To all FASTRON Customers

Ref no: 000610

Concerning Part Name: 09P/F series

Product Type: Plugable Inductor

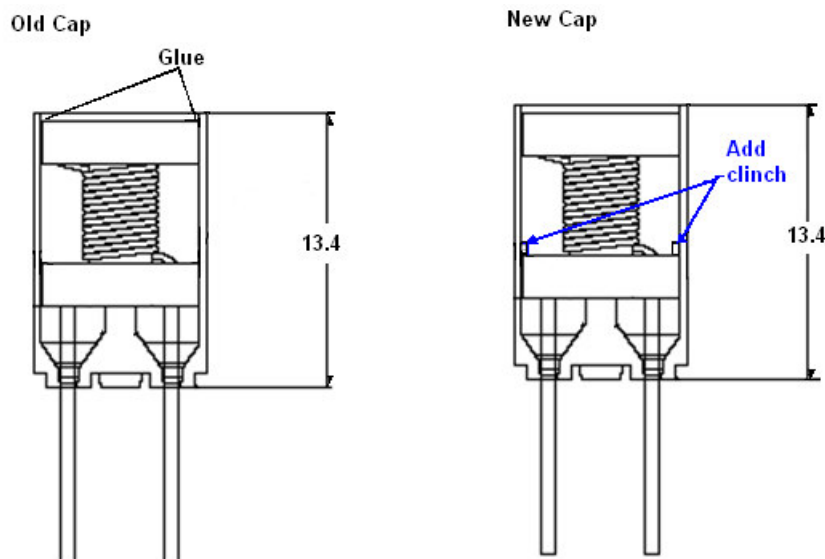
Description of Change: To eliminate the glue used for fixing the cap onto the core by adding a mechanical clinch on two sides located on the inside of the cap.

Reason: To continually improve our inductors by making them and the process more environmental friendly.

Expected Influence: No influence in electrical parameters.

Product Availability: Production lot from week 44 onwards
